# Technical Service Bulletin

<b>Subject:</b>  KNOCKING NOISE FROM FRONT SUSPENSION	<b>Bulletin No.:</b> 02-002/25
	<b>Last Issued :</b> 09/24/2025

► Replacement parts location

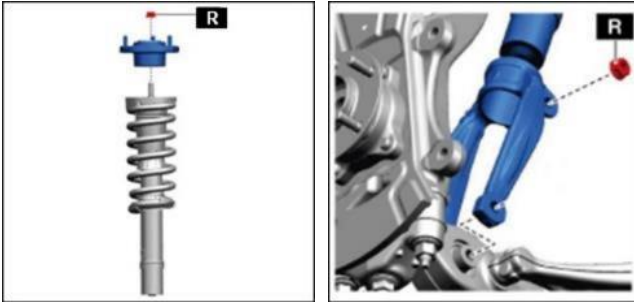
Some vehicles may experience a knocking noise from the front suspension when driving on a rough road or traveling over bumps. This noise is caused by a gap between the front strut bump stopper and the mounting rubber that is pushed up when roads are bumpy. To eliminate this concern, the outer diameter of the bump stopper has been modified to prevent the knocking sound during driving on a rough road or traveling over bumps.

3. Replace the front strut bump stoppers with the modified ones.
4. Assemble and install the front shock absorber and coil spring in the reverse order of removal.
5. Verify the repair.
